Product Change Notification

Date Issued :	November 14, 2022	PCN Number :	512909
Reason for Change :	Capacity change or tool replacement		
Description of Change :	This notice is to inform you that Molex Lincoln Nebraska is adding additional tooling that will affect the product listed. New tooling will be exact replica of current tooling. There will be no change to the product Fit, Form, Function or Appearance when compared to current tooling.		
Reason for Short Notice :	Capacity Increase		
Assessment of Change :	First Article Inspection		
Planned Implementation Date :	February 24, 2023		
Sample Availability Date:	December 16, 2022		
Internal Molex Qualification Date :	January 20, 2023		
Last date to request Samples by Customer :	January 16, 2023		
Traceability Code Markings / Date :	Product made after planned implementation date can contain the change

■ 5566-02
— Mini-Fit Jr

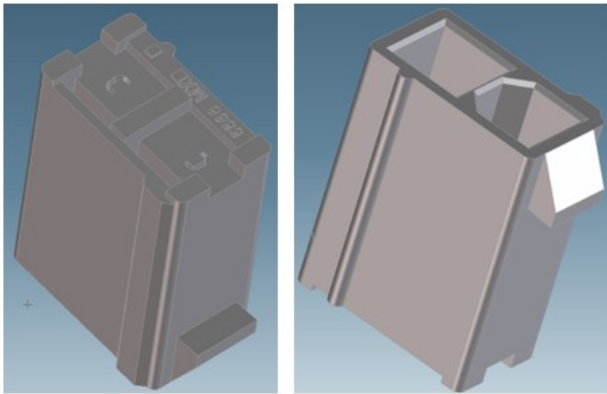
Before Picture
